**Seismic Walkdown Checklist (SWC)**

Equipment ID No.: 2-5749

Equipment Description: COOLER, CUBICLE - 2DG CW PMP CUB COOLER

Project: Quad Cities 2 SWEL

Equipment Description: SWGR 23-1

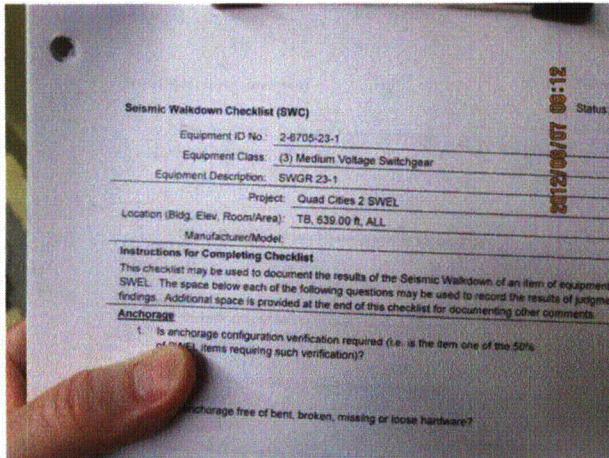
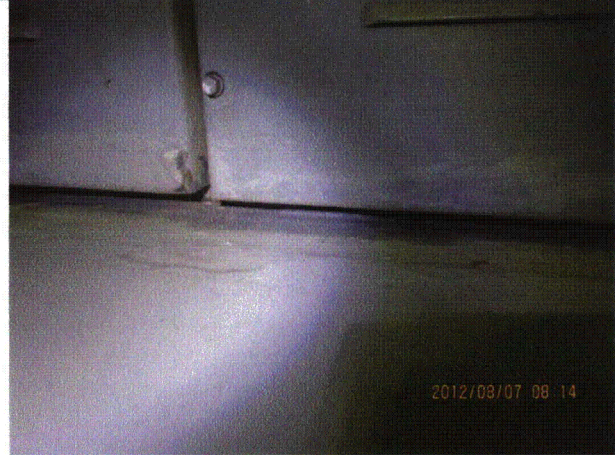
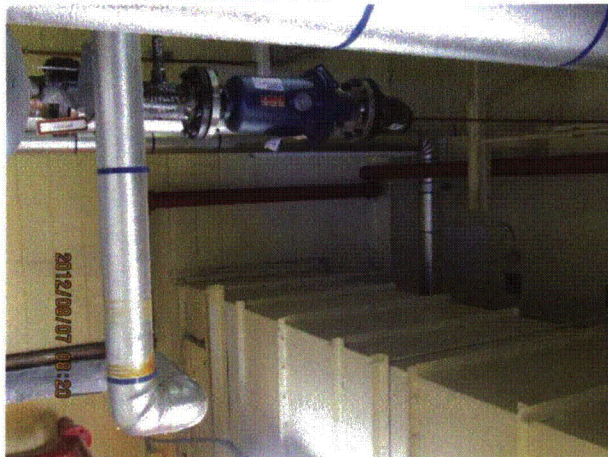
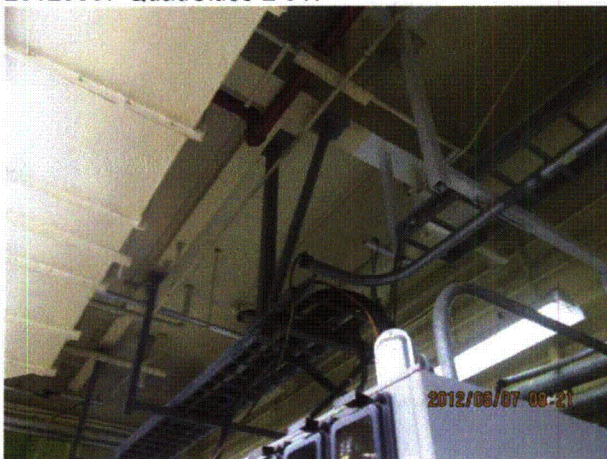
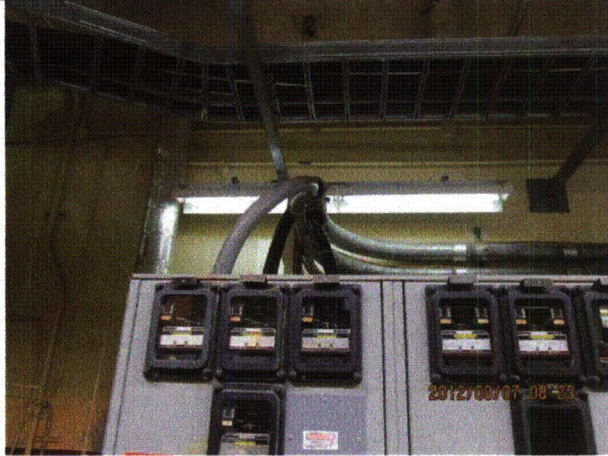
4. Is the anchorage free of visible cracks in the concrete near the anchors? Yes  
*Minor shrinkage cracks in floor and wall judged to be acceptable.*

7. Are soft targets free from impact by nearby equipment or structures? Yes
8. Are overhead equipment, distribution systems, ceiling tiles and lighting, and masonry block walls not likely to collapse onto the equipment? Yes  
*Overhead light fixtures judged to be acceptable. Masonry wall in vicinity restrained at top and judged to be acceptable.*
9. Do attached lines have adequate flexibility to avoid damage? Yes
10. Based on the above seismic interaction evaluations, is equipment free of potentially adverse seismic interaction effects? Yes

Equipment Description: SWGR 28

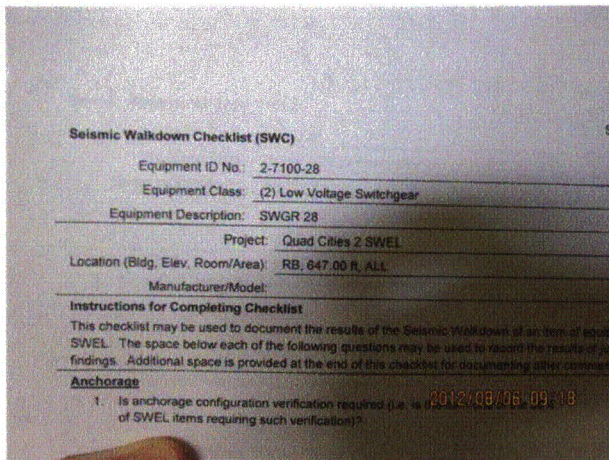
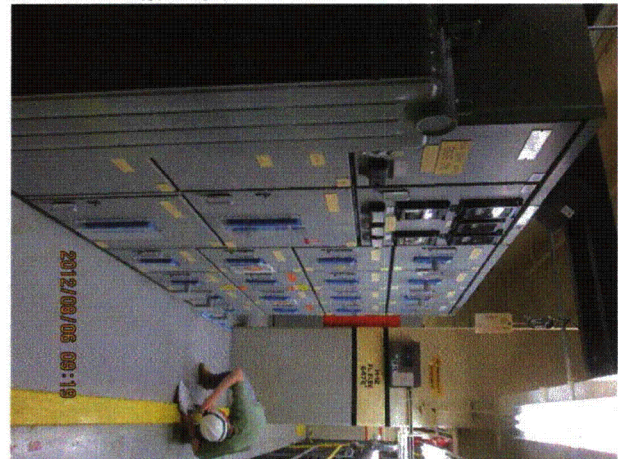
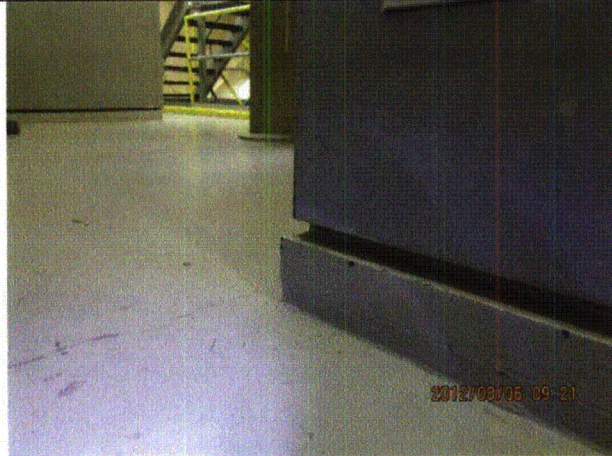
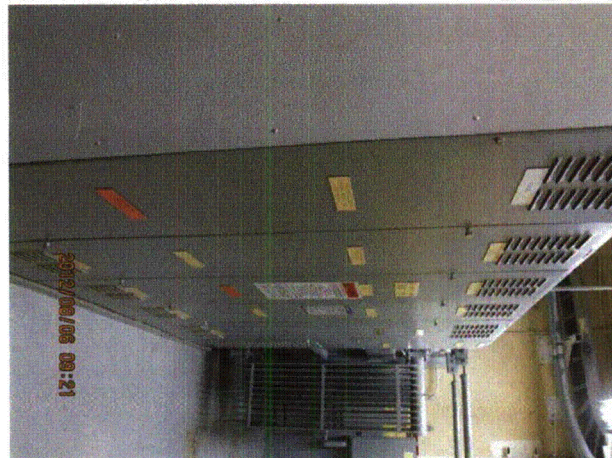
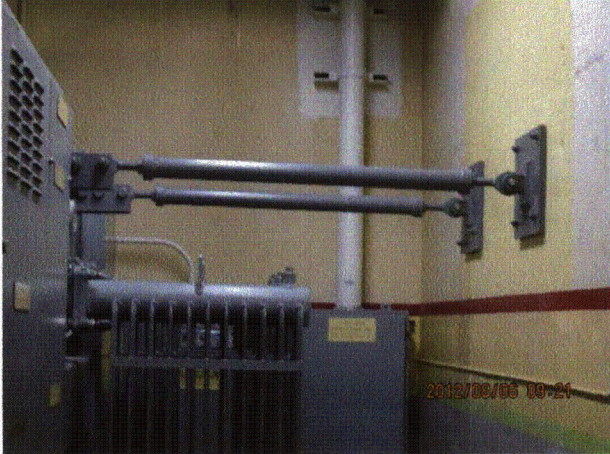
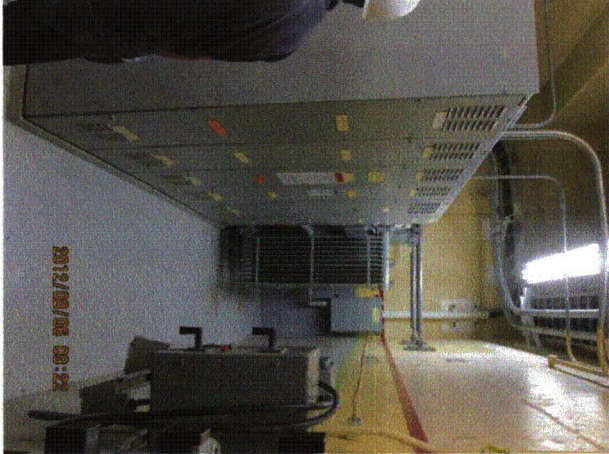
11. Have you looked for and found no adverse seismic conditions that could adversely affect the safety functions of the equipment? Yes  
*Trolley on top of switchgear free to roll; not pinned against movement. Trolley place in middle of switchgear away from end stops to mitigate vibration effects due to hitting stop. See IR 1397866.*
